PRODUCT BULLETIN

Bulletin #: FP-19_02-Ford/Omicraft
Customer: All Ford Customers
Date: January 30, 2019
Subject: Cartridge Filter – New Design For QFL10

Bulletin #: FP-19_02-Purolator
Customer: All Purolator Customers
Date: January 30, 2019
Subject: Cartridge Filter – New Design For L15839 & TL15839

Bulletin #: FP-19_02-SOPUS
Customer: All SOPUS Customers
Date: January 30, 2019
Subject: Cartridge Filter – New Design For PZ171, PO-171 & QS171

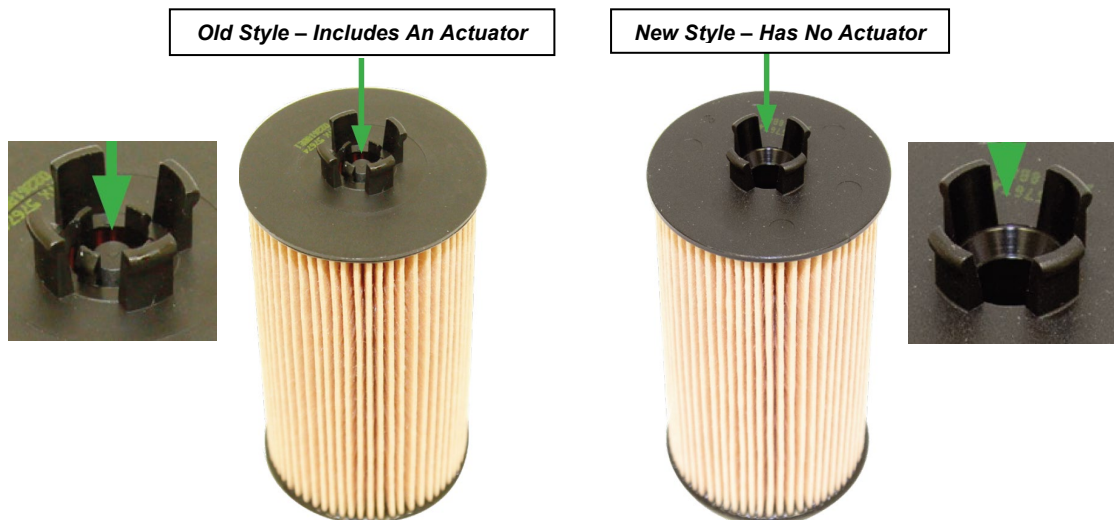
The current design includes an actuator on the top end cap. A complete redesign of the end cap has eliminated the need for the actuator, and aligns with the OE styling. The catalog information remains exactly the same. This is a running change - please use FIFO inventory rotation practices to sell through older inventories first.

Please note: the old style filter must be installed in-tact with the actuator in place to fit and function properly. Physical removal of the actuator from older style cartridges will damage the filter and will void all warranties.

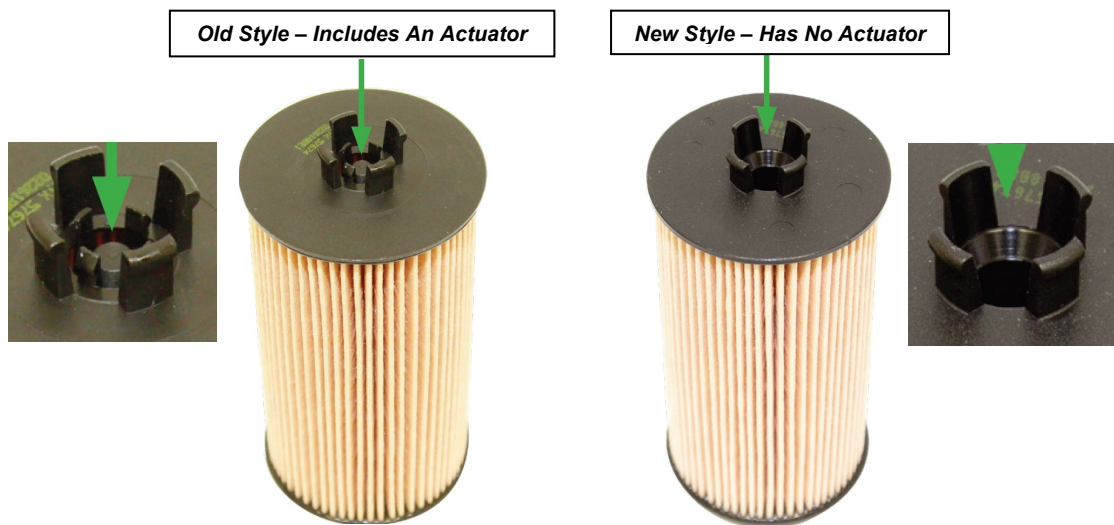
The current design includes an actuator on the top end cap. A complete redesign of the end cap has eliminated the need for the actuator, and aligns with the OE styling. The catalog information remains exactly the same. This is a running change - please use FIFO inventory rotation practices to sell through older inventories first.

Please note: the old style filter must be installed in-tact with the actuator in place to fit and function properly. Physical removal of the actuator from older style cartridges will damage the filter and will void all warranties.

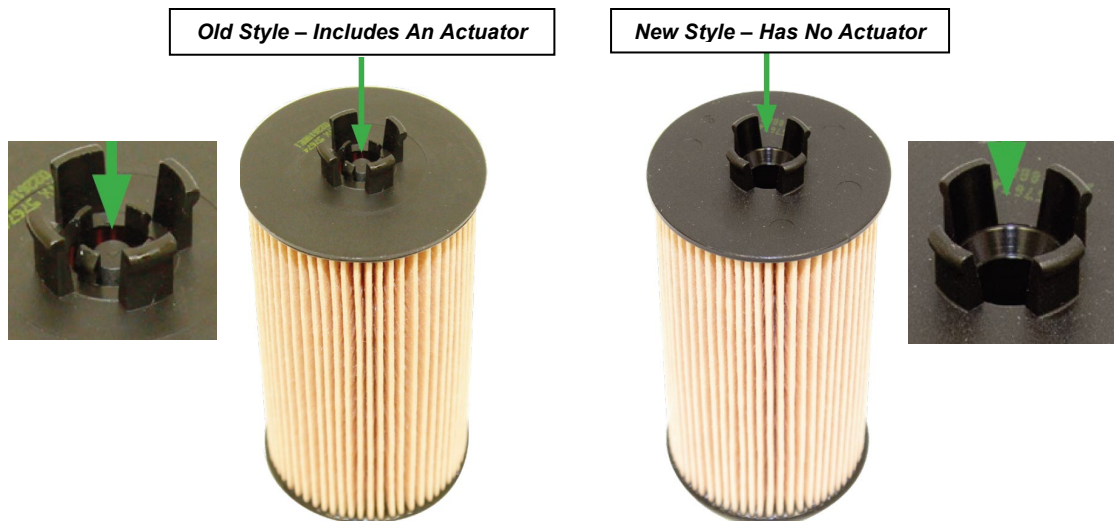
The current design includes an actuator on the top end cap. A complete redesign of the end cap has eliminated the need for the actuator, and aligns with the OE styling. The catalog information remains exactly the same. This is a running change - please use FIFO inventory rotation practices to sell through older inventories first.

Please note: the old style filter must be installed in-tact with the actuator in place to fit and function properly. Physical removal of the actuator from older style cartridges will damage the filter and will void all warranties.
